REVISION NO. 1

PROFILE, ALIGNMENT AND GRADE OF PAGE 1

SANITARY SEWERS

TRACT NO. 38301
PRIVATE CONTRACT NO. 10186

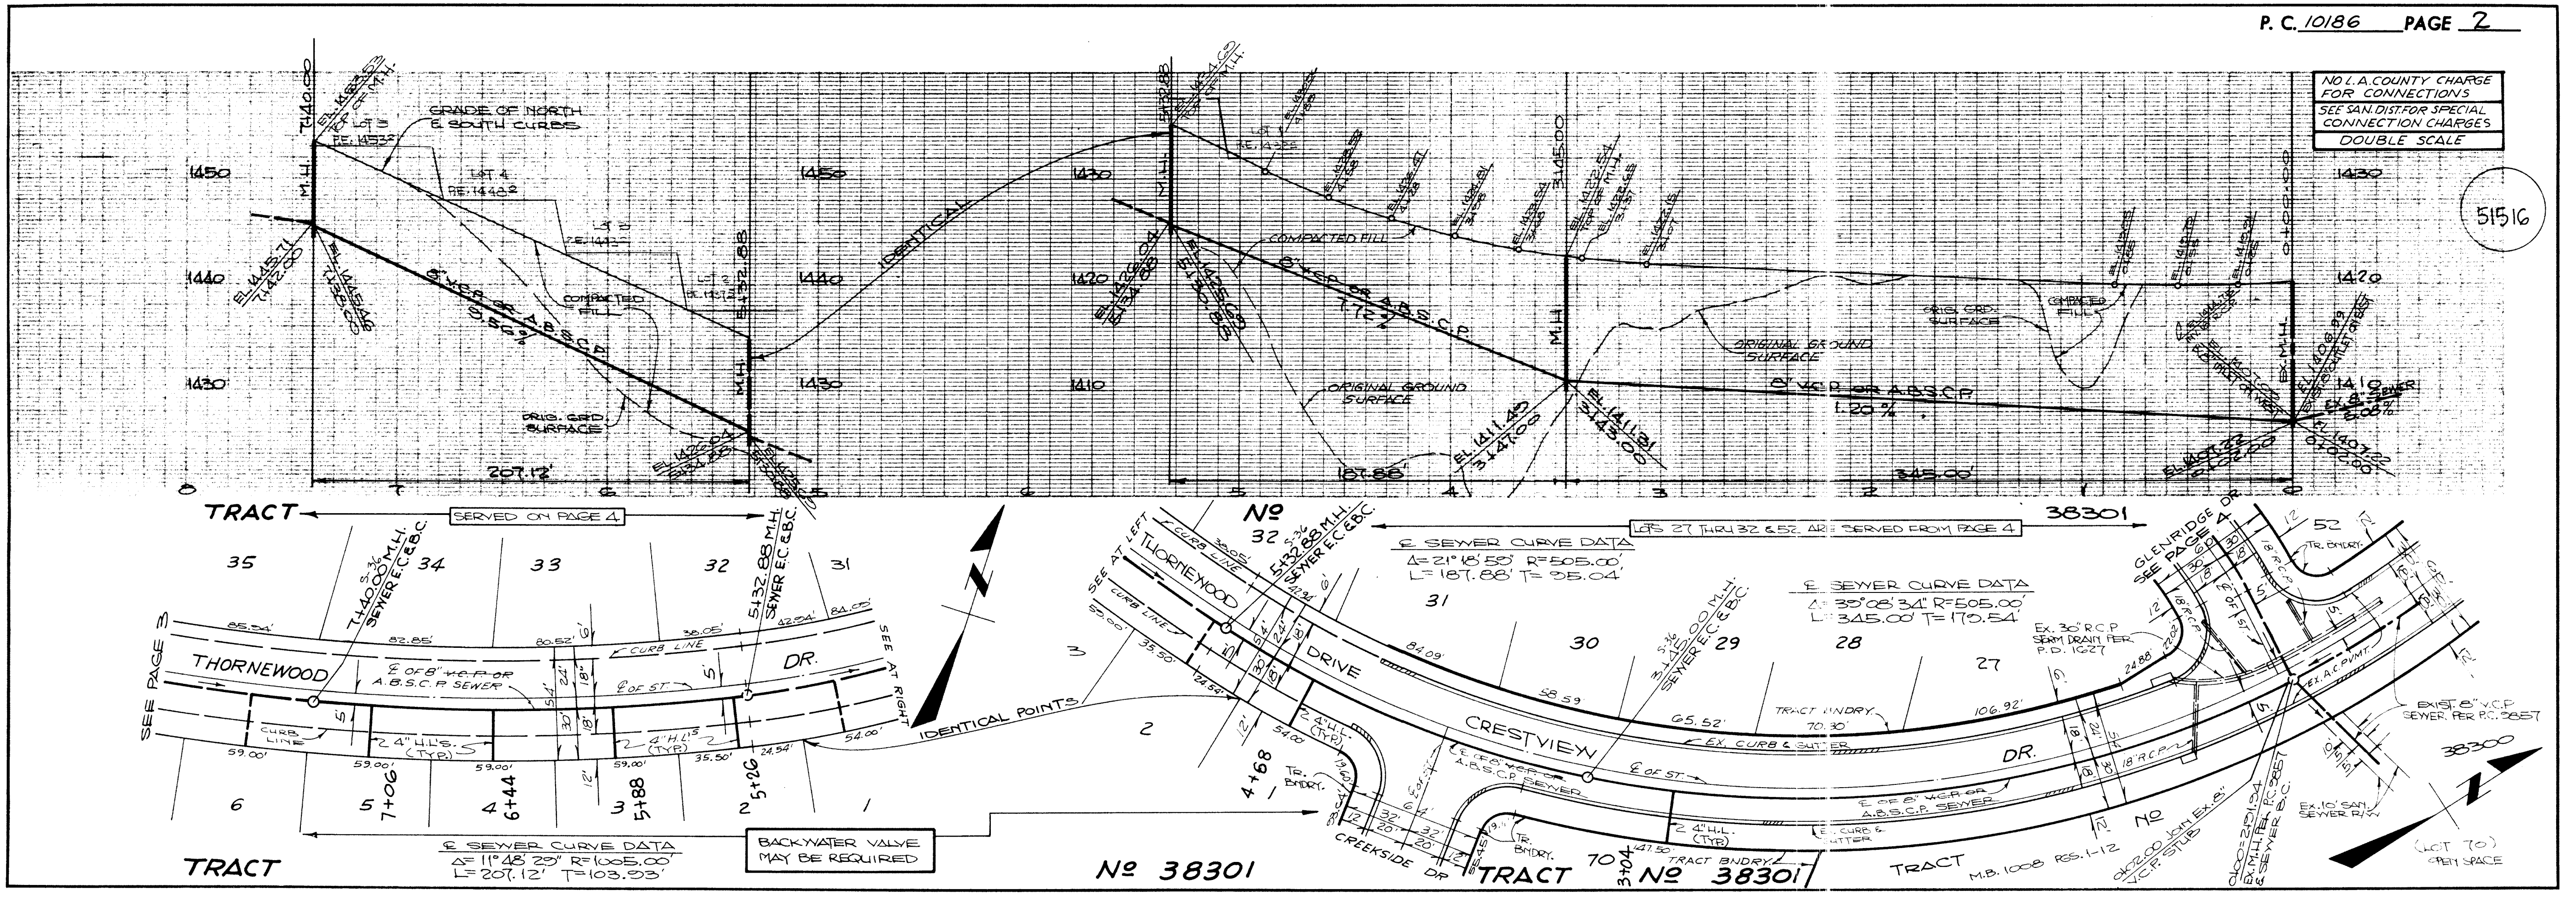
PAGE 2	REVISE STREET GRADES FROM STA. 0+00 TO STA. 4+08
PAGE 4	REVISE STREET GRADES & VERTICAL SEWER DESIGN FROM STA. 1+00 TO STA. 3+08
PAGE 5A	REVISE STREET GRADES & VERTICAL SEWER DESIGN FROM STA. 3+08 TO STA. 11+25 (T)
PAGE 5B	REVISE STREET GRADES & VERTICAL SEWER DESIGN FROM STA. 1+00 TO STA. 4+22.82
